Technical Service Information

FORD E4OD HARSH 3-4 SHIFT

Figure 1

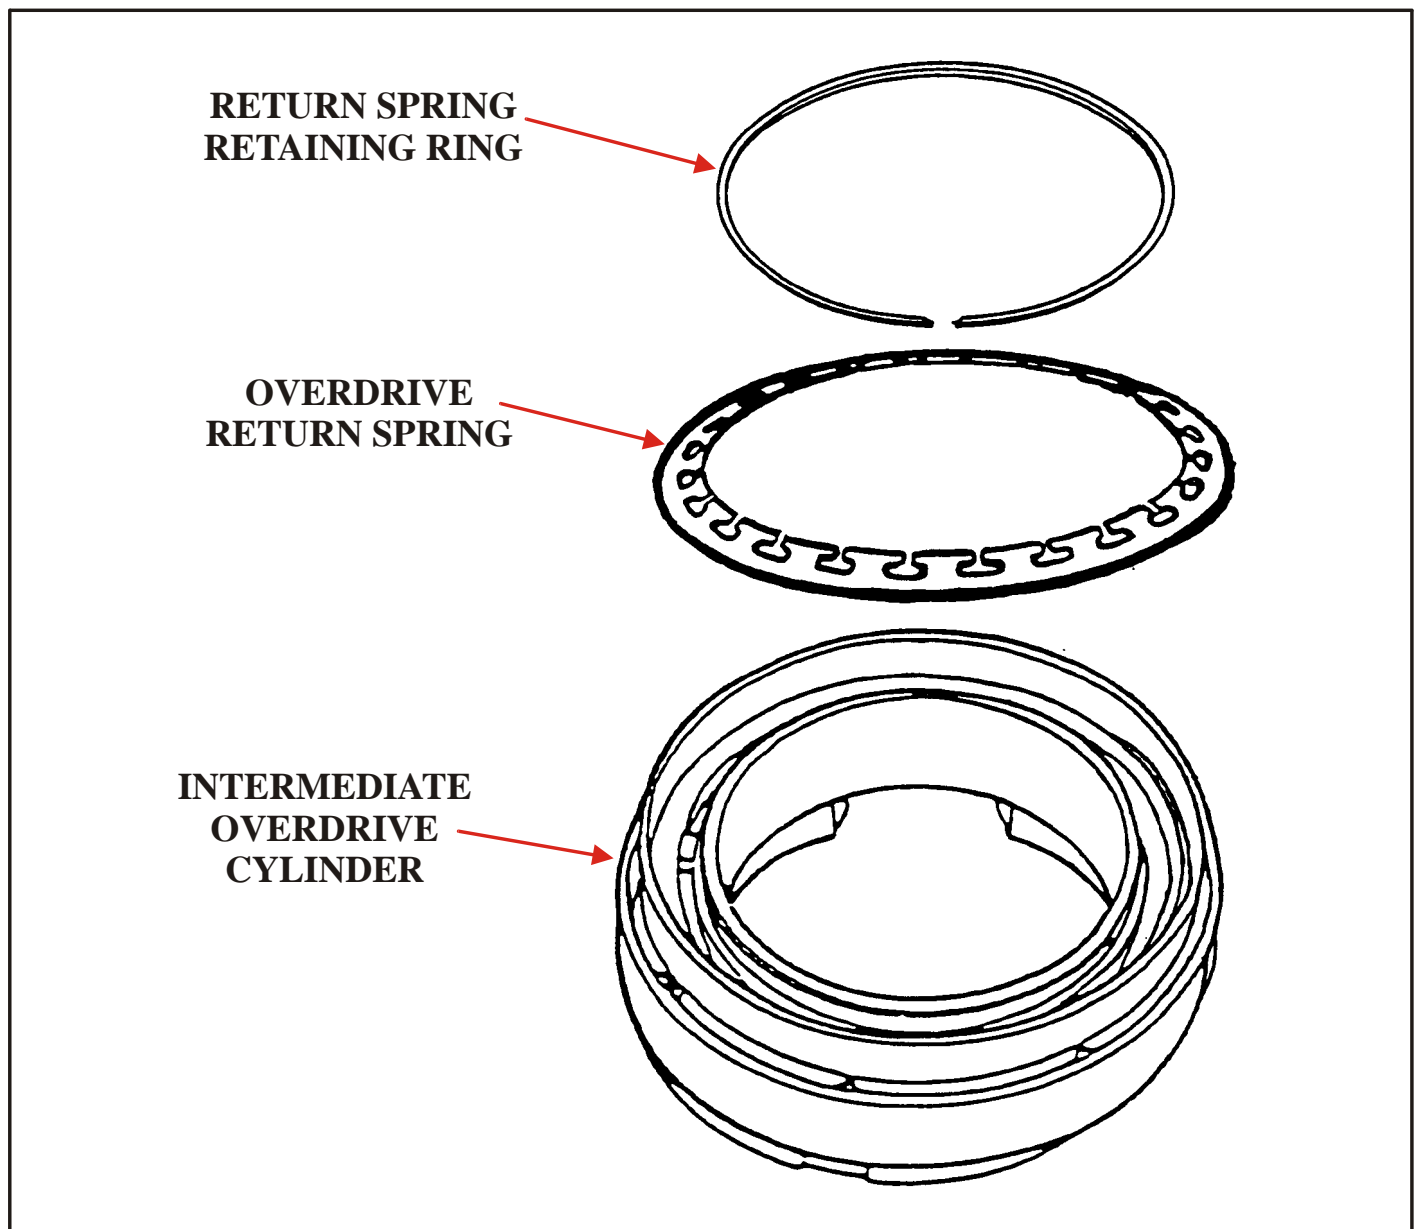
COMPLAINT: Harsh 3-4 shift, and/or upon transmission dis-assembly the O.D. Clutch retaining ring is dislodged from groove (See Figure 1).

CAUSE: Insufficient snap ring tension.

CORRECTION: Replace snap ring with updated (More Tension) snap ring available under OEM part number F0TZ-7A527-A.
